AGENDA
CITY OF TAYLOR, TEXAS
PLANNING & ZONING COMMISSION MEETING
CITY HALL COUNCIL CHAMBERS
400 PORTER STREET
TAYLOR, TX
JUNE 9, 2026, 6:00 PM

Planning & Zoning Commission Meeting June 9, 2026 Transmittal Letter

FINAL PLAT
OF
NORTH VILLAGE, PHASE 1

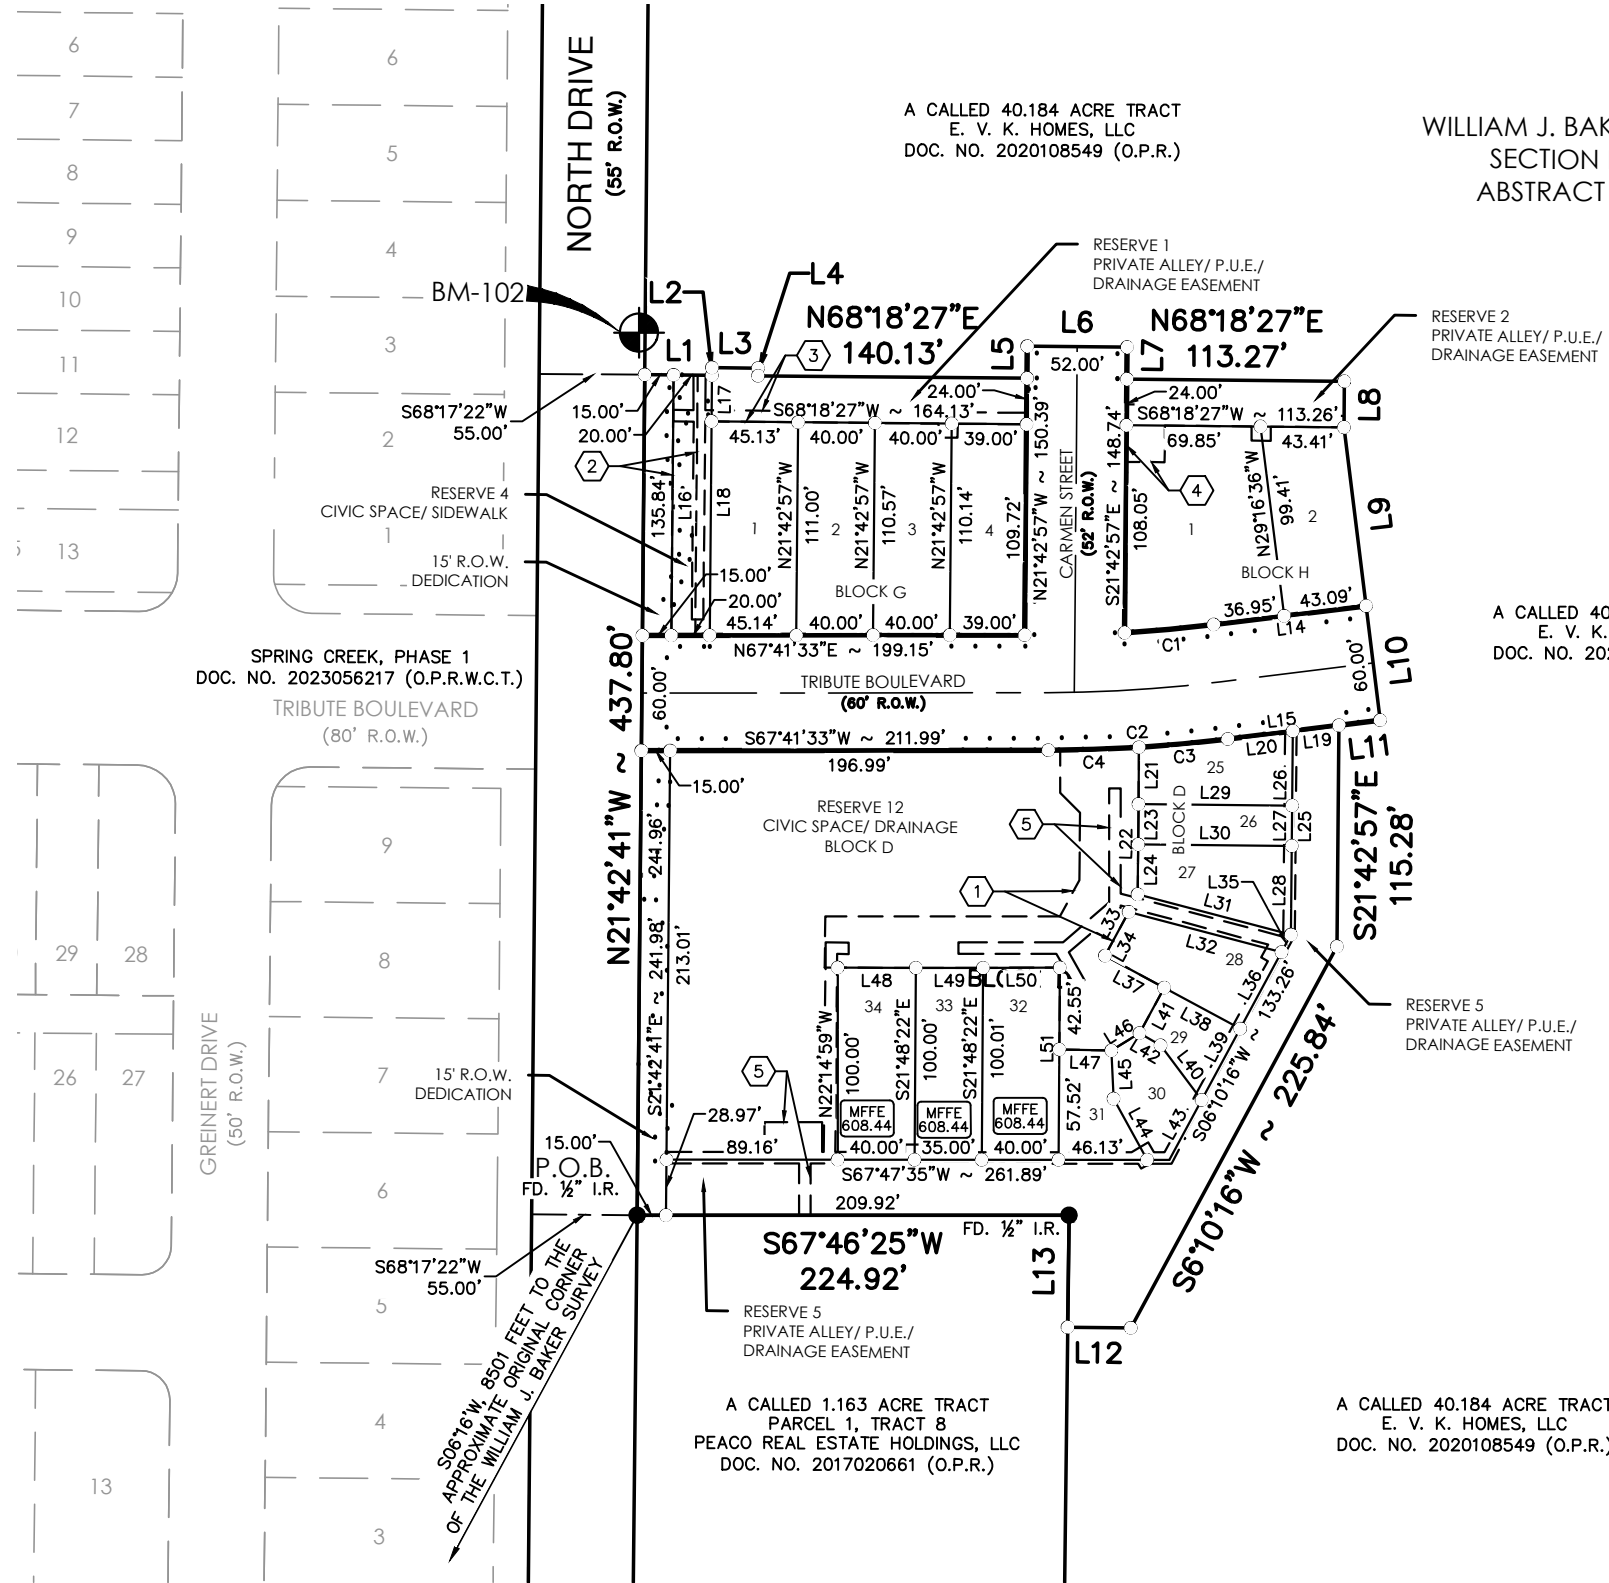
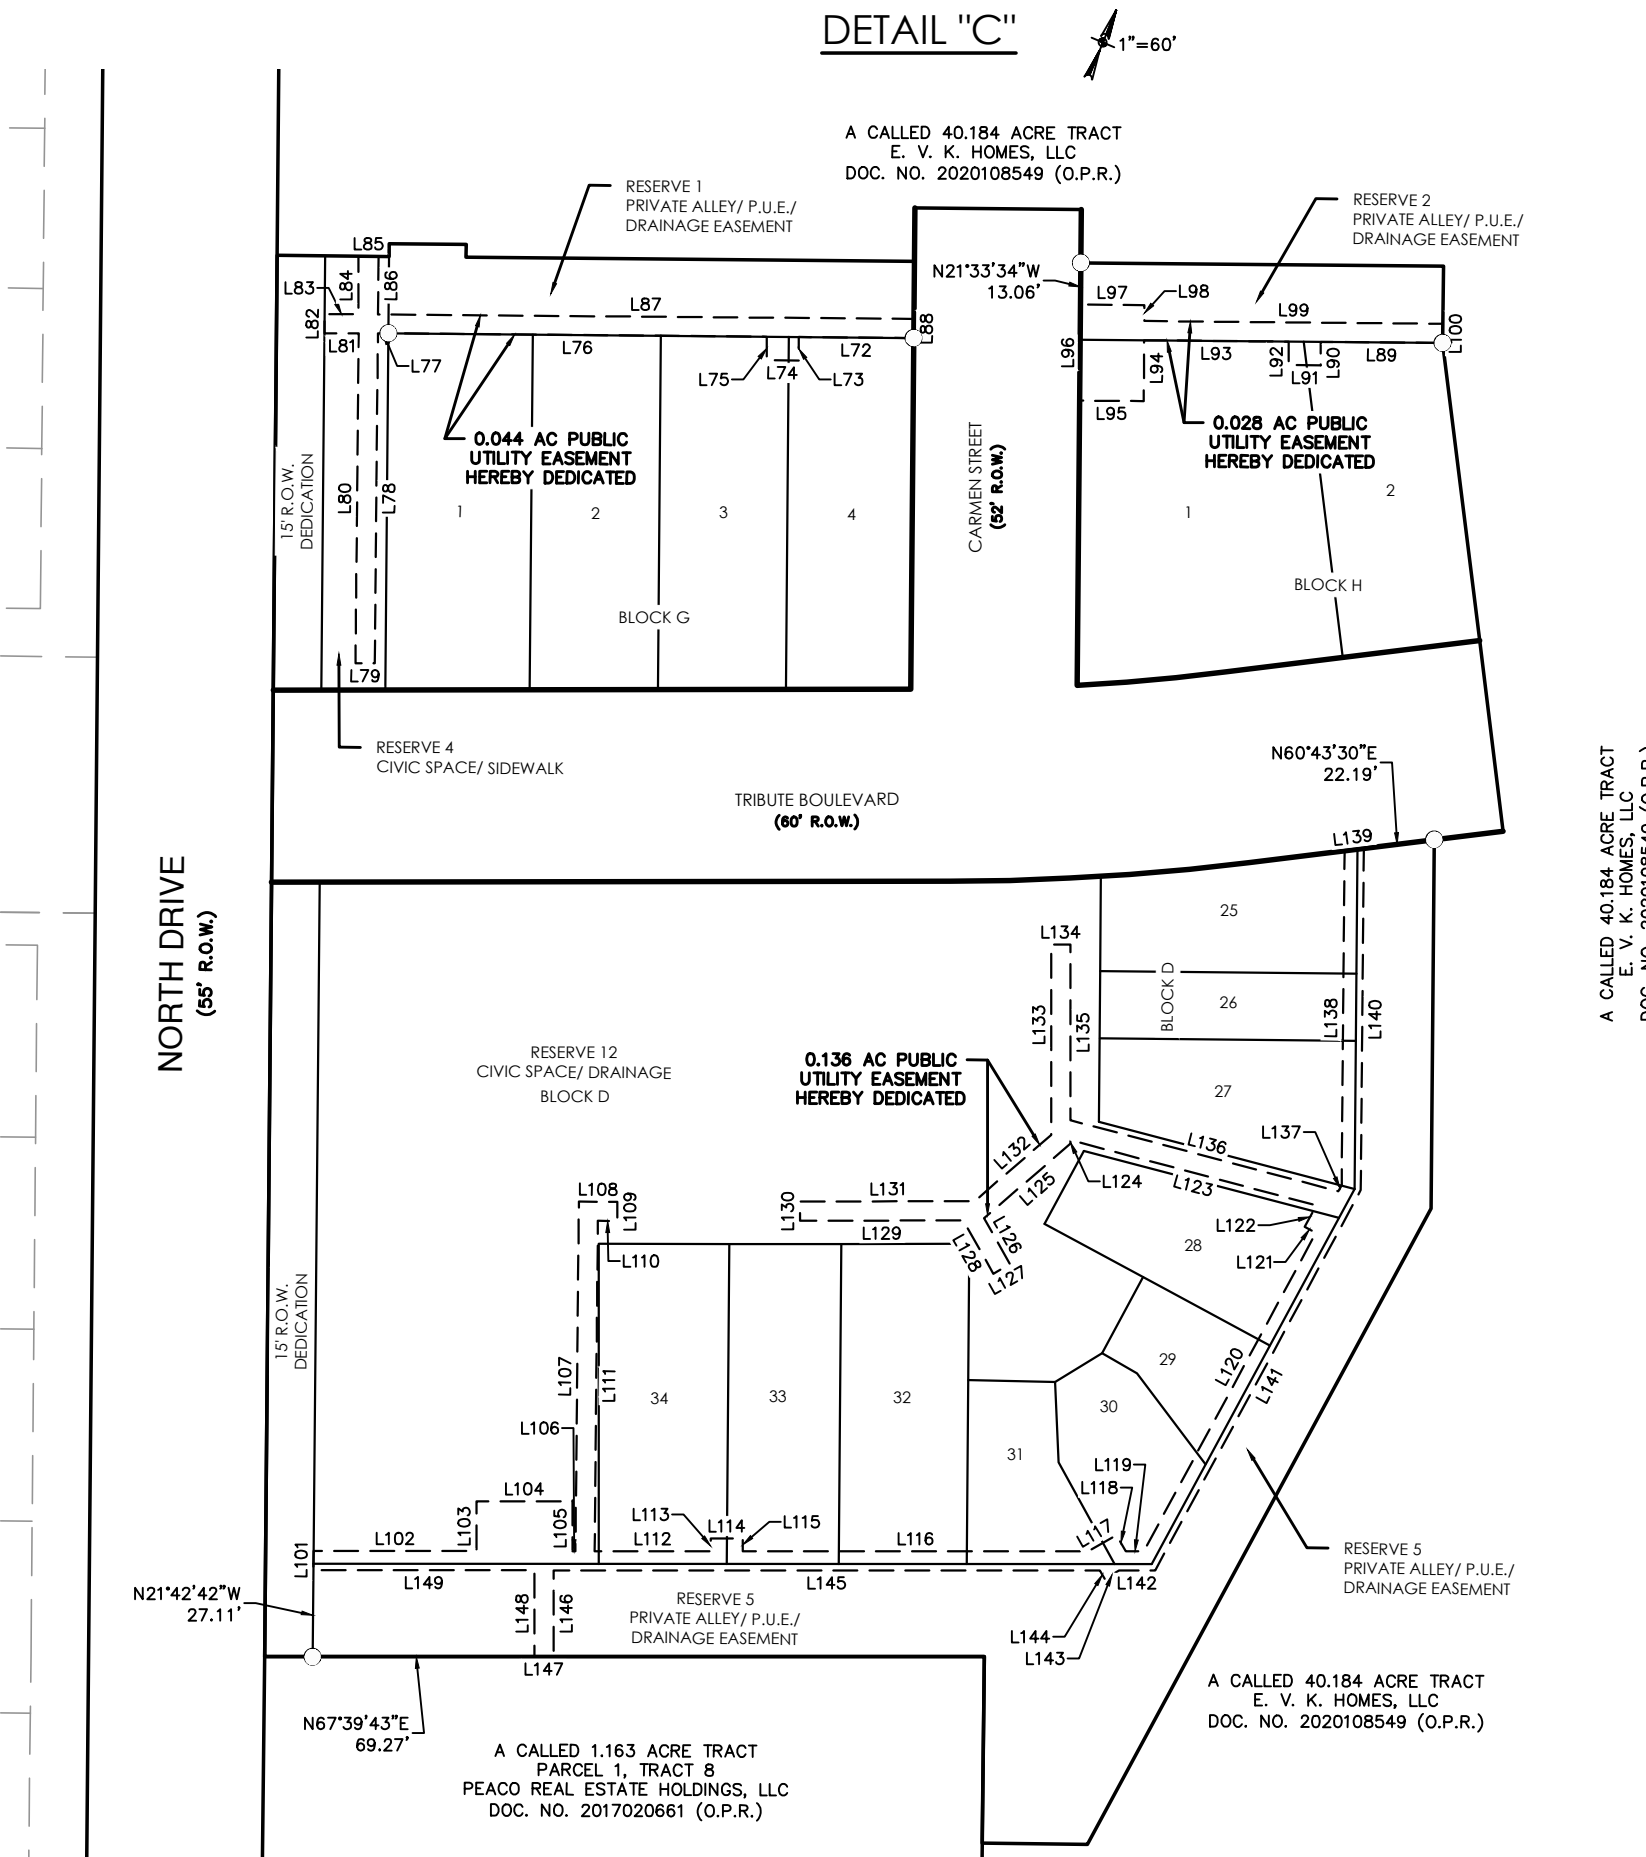
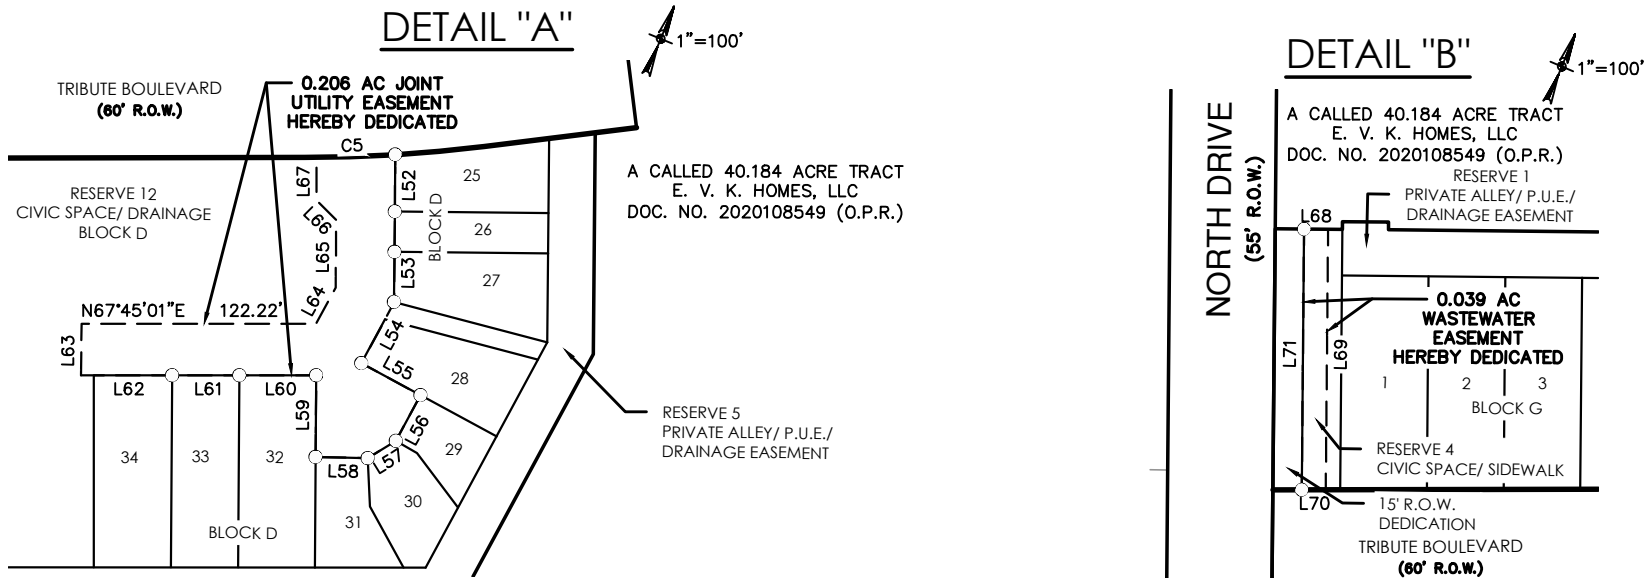
1. Sheet 1 of 3 - See sheet 2 for comment regarding utility easements in this area
2. Sheet 1 of 3 - Show street centerlines for intersecting streets
3. Sheet 1 of 3 - Provide bearing and distance for street centerlines
4. Sheet 1 of 3 - Please include a table with lots requiring a Minimum Finished Floor Elevation
5. Sheet 1 of 3 - Revised submittal date year
6. Sheet 1 of 3 - Include reserves in summary
7. Sheet 1 of 3 - Recommend increasing scale for ease of viewing (e.g. 1"=60')
8. Sheet 1 of 3 - North Drive is existing ROW. Show as unbolded on the plat
9. Sheet 2 of 3 - From understanding with the planned development, Civic Spaces are considered a public ROW and do not require a separate utility easement
10. Sheet 2 of 3 - Maintenance agreement noted on final plat per LDC 3.8.4.2 DRAINAGE.
11. Sheet 2 of 3 - Verify plat note #8 with Taylor Fire Dept.

12. Sheet 2 of 3 - Notate requirement of offsite wastewater easement on along east side of North Drive
13. Sheet 2 of 3 - Recommend moving row to end to avoid confusion of table heading for lot
14. Sheet 3 of 3 - Include section symbols for each certificate heading, as applicable (Typical)
15. Sheet 3 of 3 - Update P&Z Certificate, subdivision name to "North Village Phase 1"
16. Sheet 3 of 3 - Provide full subdivision name in certificate North Village Phase 1
17. Sheet 3 of 3 - Remove text marked out. When there is a lien holder, a certificate is added. If no lien holder the text is added to the certification so the Owner attests accordingly.
18. Sheet 3 of 3 - Provide full subdivision name in certificate North Village Phase 1

1. Sheet 1 of 3 – Verify that the property address is included in the lower-right title block per standard title block requirements.
2. Sheet 1 of 3 – Confirm revision notes block is present in the lower-right title block.
3. Sheet 1 of 3 – The top-center plat description must follow the required format per the Subdivision Ordinance:

4. Sheet 2 of 3 – Verify utility providers listed in Note 5 are consistent with applicable CCN service area designations for water and wastewater.
5. Sheet 3 of 3 – County Clerk certificate heading still reads "SPRING CREEK, PHASE 2." Update to "North Village, Phase 1" (separate instance from the P&Z certificate already noted in Engineering Comment #14).
